UNITED STATES PATENT AND TRADEMARK OFFICE

APPLICATION NO.	FILING DATE	FIRST NAMED INVENTOR	ATTORNEY DOCKET NO.	CONFIRMATION NO.
09/865,514	05/29/2001	Kazuma Okuda	010568	3133

**Office Action Summary**

The following title is suggested: Outer rotor type motor/generator with an air inlet passage and air gap shield coverings on stator.

第 3 図

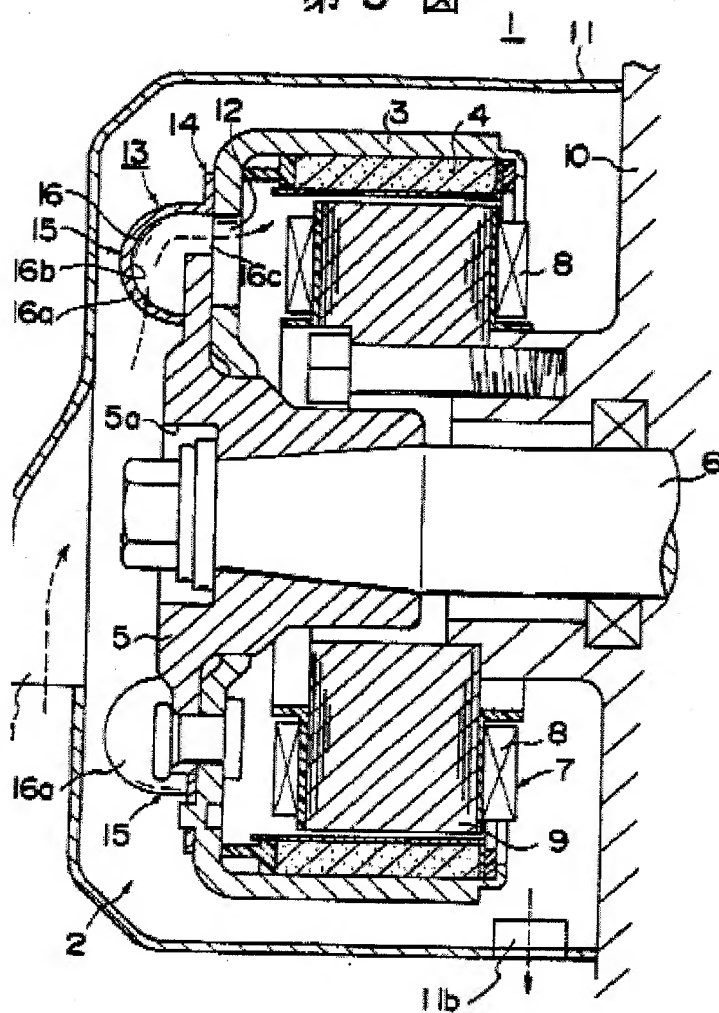
Kusase et al. illustrates a generator motor (100) in Figure 1, that is positioned between a pulley (10) and an engine housing (1) with a pulley (10) fitted over an end part of a crank shaft (2) with the stator yoke (21) positioned to the protruding wall (20) of the engine housing (1). Furthermore, a rotor yoke (16) is secured fixedly on to the inner peripheral face end (14) of the pulley (10), with the rotor yoke (16) facing the stator yoke (21) diagonally from an air gap (A). Additionally, Figure 1 illustrates an air passage (B) that is positioned between engine housing (1) and the peripheral wall edge (C) of the pulley (10). In addition, Kusase et al. illustrates in Figure 4 a recessed space (S). However, Kusase et al. does not illustrate a crank pulley with fan blades positioned on to the side walls at are extending radially outward from an end of the crank shaft and stator coils cooled from air flowing through the annular space by way of the air passage with the air being discharged through the fan blades.

第 4 圖

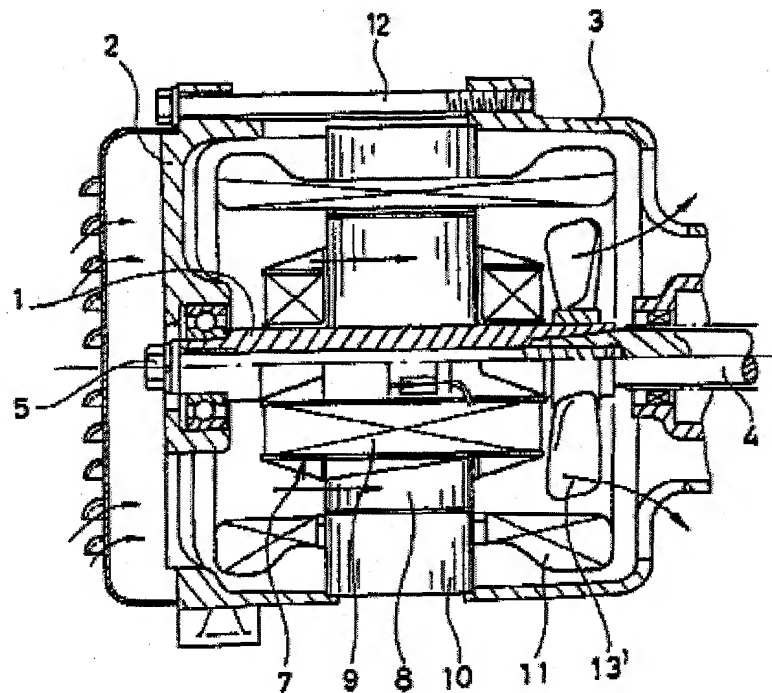
It illustrates in Figure 4 a generator in which air flows through a stator core (8) with coils (11) and is discharged through the fan blades (13') to the outside of the generator.

It would have been obvious at the time the invention was made to a person having ordinary skill in the art to modify Kusase et al.'s invention by adding radially extending fan blades from the crankshaft that is positioned onto the pulley in order to enhance the cooling effect. As well as having airflow through the stator core and windings to be discharged through the fan blades to the outside of the generator in order to shorten axial length.

FIG.2

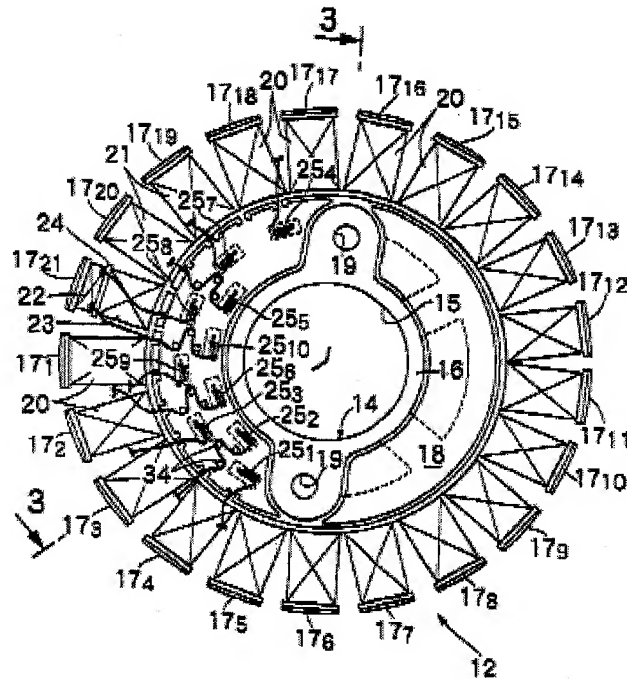
Kusase et al. and Yoda et al. and Ito and Gritter et al. teach all of claims 1 and 2 except for the plurality of the stator core and coils with the coils wound around the cores and projecting in a circumferential direction. Kakinuma et al. discloses in Figure 2 a stator (12) with stator cores (14) formed from a plurality of core plates with coils (20) and formed into a T-shape and projectingly provided from a distance apart from one another. However, Kakinuma et al fails to show cores with coils wound around the cores and an air passages between the coils.

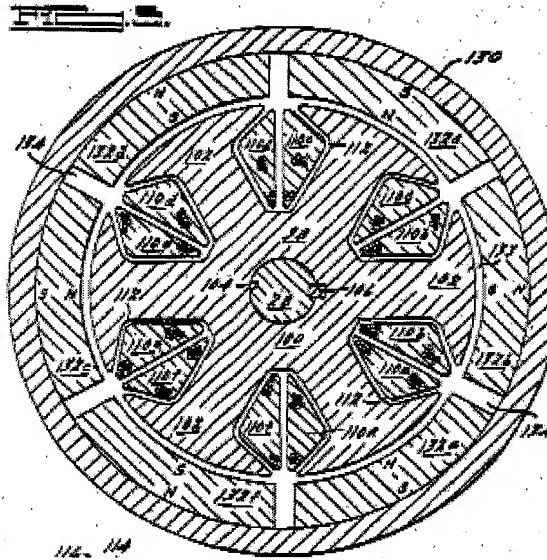
Gritter et al. illustrates in Figure 5 a stator assembly in which the coils (110) are wound around each armature tooth (102) and are extrapolative in a circumferential direction with an air passage (A) between the coils (110a through 110f).

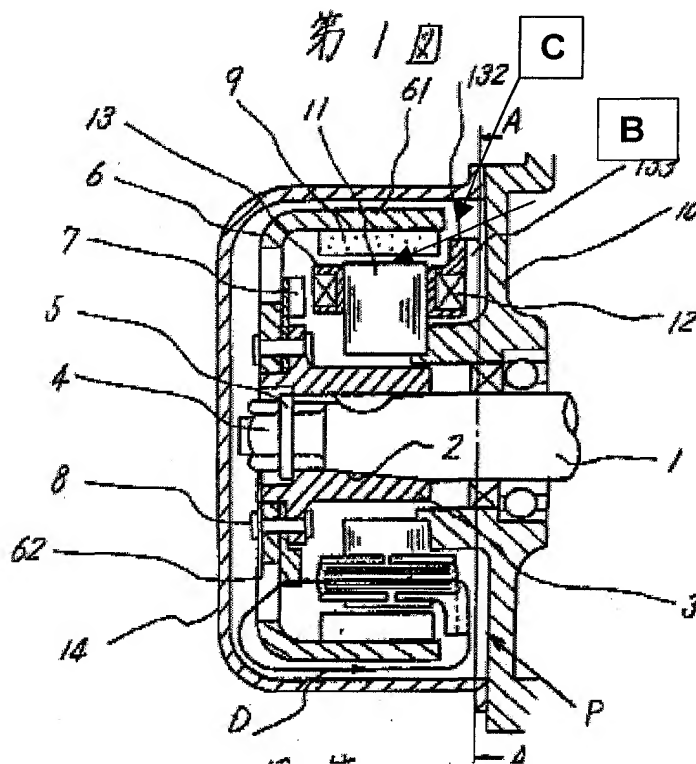
the outer periphery of the stator. Kamiyama illustrates in Figure 1 a generator in which a guide fin (133) acting as a cover for the air gap (A) is projecting from the upper end of the stator coil (12) facing an air inlet passage (B) for effective cooling of the coils.

It would have been obvious at the time the invention was made to a person having ordinary skill in the art to modify Kakinuma et al.'s invention by adding a guide fin (133) projecting from the top edge of the stator coil (12) in order to efficiently circulate the cooling air for guiding fluid in order to effectively cool the coils (12).
